Service Bulletin

Bulletin No.: PI1181

Subject: Oil Pan Heater Cord Replacement

Models: 2012-2014 Chevrolet Sonic
Equipped with 1.8L Engines (RPO LUW, LWE)
and Oil Pan Heater (RPO KPK)
Vehicles Built Prior to September 6, 2013

3721569

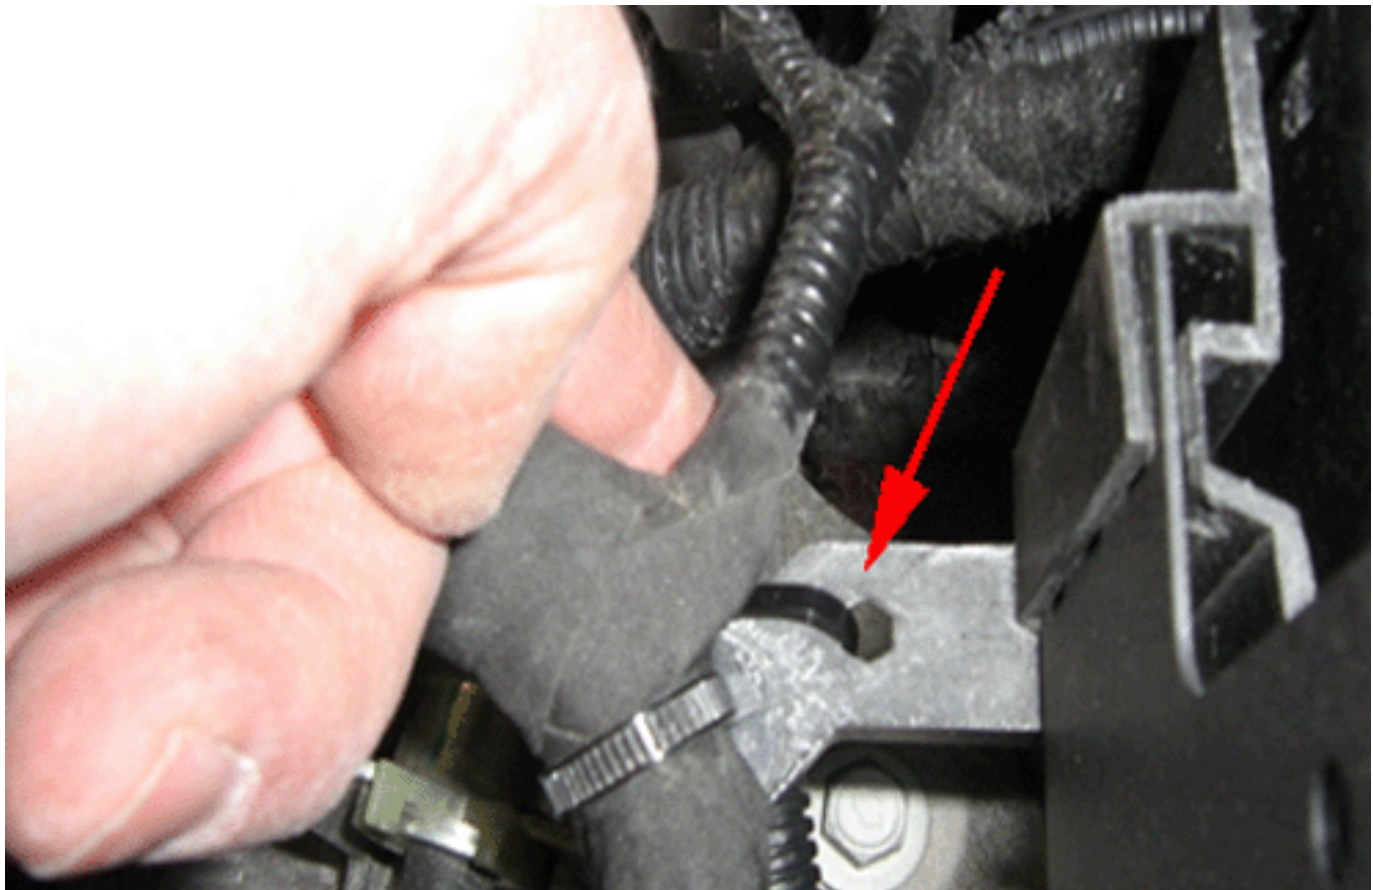
The Sonic oil pan heater cord is bundled in production with the battery cable harness. Should the heater cord become damaged and require replacement, the complete battery harness has to be replaced.

Instead of replacing the complete battery harness, route the oil pan heater cord (P/N provided below) to the existing battery harness, using the following procedure.

1. Prep the new cord for installation by removing all the clips except the one closest to the female end of the cord.
2. Remove each end of the cord where it enters and exits the vehicle harness and discard the ends and associated clips.
3. Plug the new cord into the oil pan heater and route the cord along the top of the existing vehicle harness using tie straps to secure.

- Tie strap the new cord to the existing hole on the battery tray while routing the cord underneath the ECM harness as shown in the illustration above.

- Route the remainder portion of the cord exiting between the high and low beam headlamp as shown in the illustration above.
